SUMMARY OF TOPICS

The following changes in requirements to the Standard for CSDS Nov Sat Testing C, UL 999E, are being proposed:

(NEW)
Figure 13.2
Appliance configurations

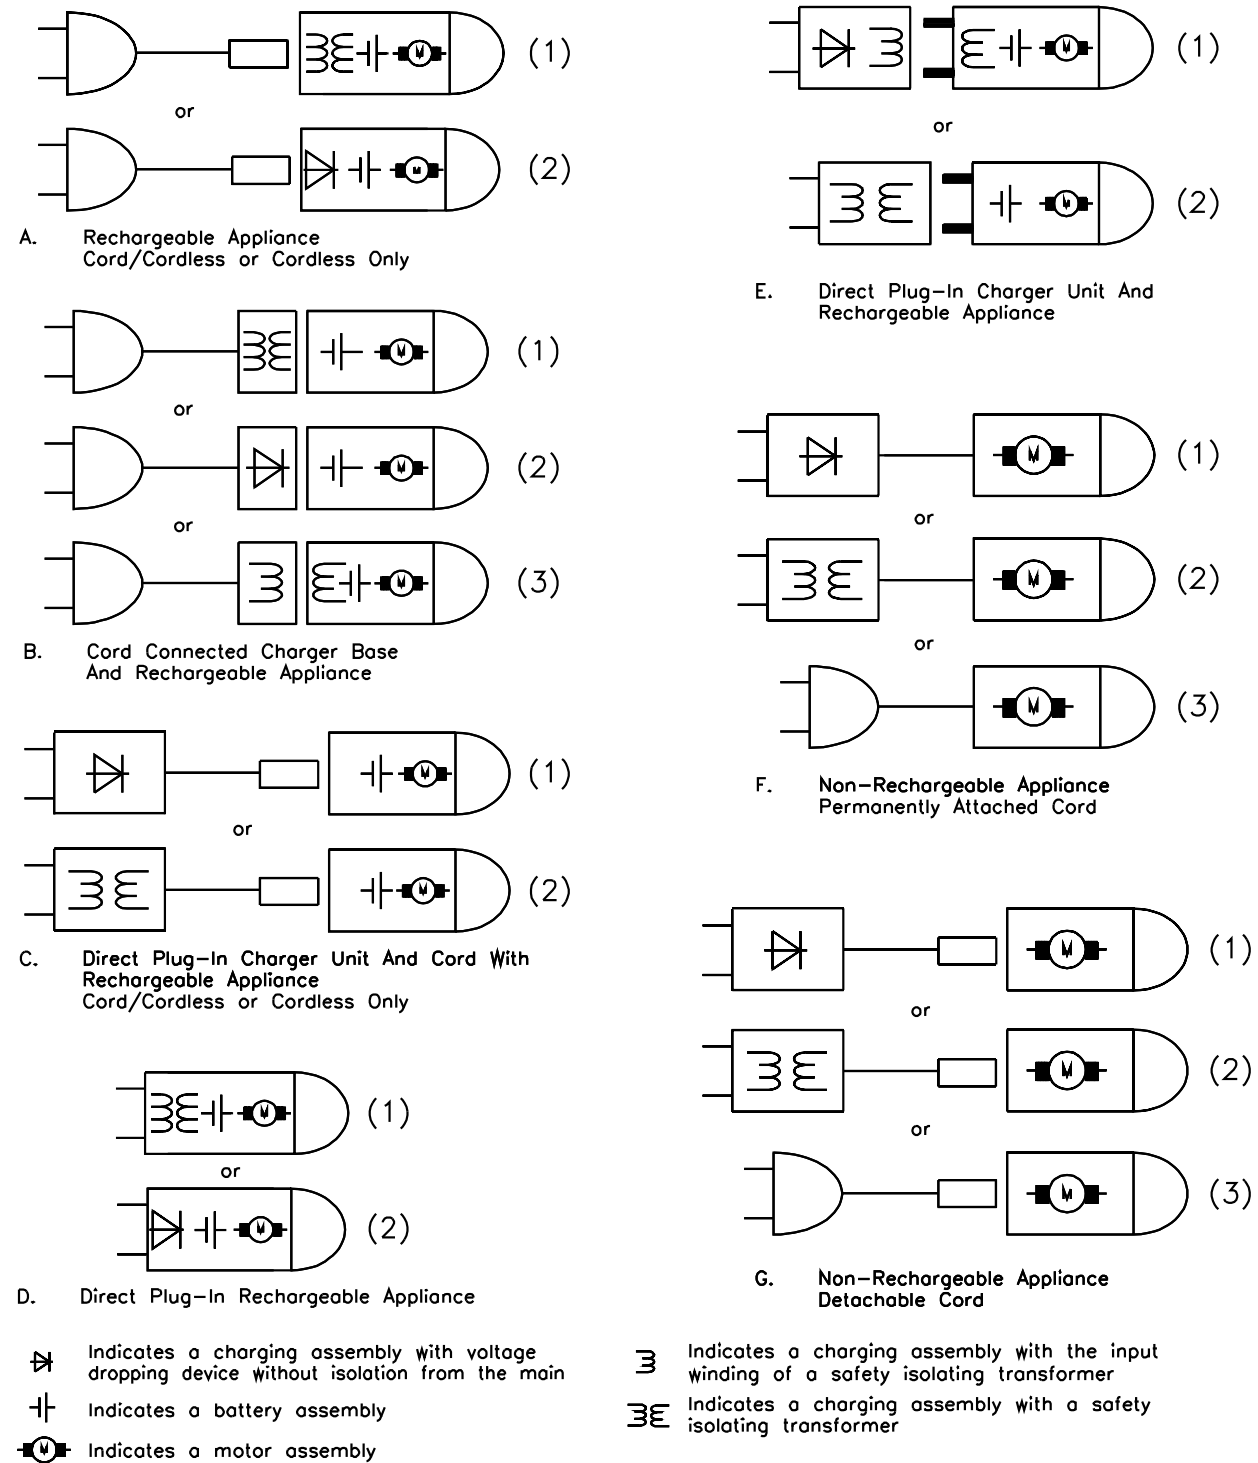
In the November 30, 1993 Report on the October 21, 1993 IAC meeting, UL indicated that the requirements for power-supply cords on charger bases for residential and commercial applications would require review and that proposed requirements would be developed. As a result of the review, UL determined that a more extensive proposal was needed to provide clarification of the requirements for all cord types and lengths. Therefore, in the Subject 1028, July 30, 1999 proposal bulletin, UL proposed to add definitions with respect to cord connected products and to revise Figure 13.2, Table 13.2, and paragraphs 13.1.1.9 – 13.1.1.12.

As a result of the comments received to the May 12, 2000 Meeting Report, UL is proposing to further revise Table 13.2 to add cord Type SVT for household and commercial hair clipper appliances for configurations A (cord/cordless) and B.

13.1.1.9 The length of ~~a~~ an attached flexible cord for an appliance configuration shown in Figure 13.2 shall be as specified in Table 13.2, including the attachment plug, and a cord set, including fittings, shall not be less than 6 feet (1.83 m).

13.1.1.10 The flexible cord for an appliance configuration shown in Figure 13.2 shall be of a Type as specified in Table 13.2 or 13.1.1.11 and 13.1.1.12, or shall be of a type of have properties such that it is at least equally as serviceable for the application.

Application	Appliance configuration in Figure 13.2	Types of cord ^e	Minimum Length ^a	
			ft	(m)
Animal clippers: 50 W or less	A (cord/cordless), F (line voltage circuit), G (line voltage circuit)	SV, SVE, SVO, SVOO, SVT, TS ^c , TST ^c	6	(1.83)
	A (cordless only), B	SJ, SJE, SJT, SJO, SJOO	6	(1.83)
	Over 50 W	A, B, F (line voltage circuit), G (line voltage circuit)	6	(1.83)
Hair clippers: Household	A (cord/cordless), F (line voltage circuit), G (line voltage circuit)	TPT ^{b,c} , TS ^c , TST ^c , SVT ^d	6	(1.83)
	A (cordless only), B	SP-2, SPE-2, SPT-2, SVT	4	(1.23)
	Commercial	A (cord/cordless), F (line voltage circuit), G (line voltage circuit)	6	(1.83)
	A (cordless only), B	SJ, SJE, SJO, SJOO, SJT, SJTO, SJTOO, SP-2, SPE-2, SPT-2, SVT	4	(1.23)
Shavers: Household	A (cord/cordless), F (line voltage circuit), G (line voltage circuit)	TPT ^{b,c}	5	(1.50)
	A (cordless only), B	SP-2, SPE-2, SPT-2	4	(1.23)

Either Hair Clipper or Shaver: Any application	C (cord/cordless), F (low voltage, limited energy), G (low voltage, limited energy)	Any	6	(1.83)
	C (cordless only)	Any	4	(1.23)

40.19 With reference to Figure 13.2, appliance configurations B, C, and E shall be marked to indicate the charger base or unit the appliance is to be used with.
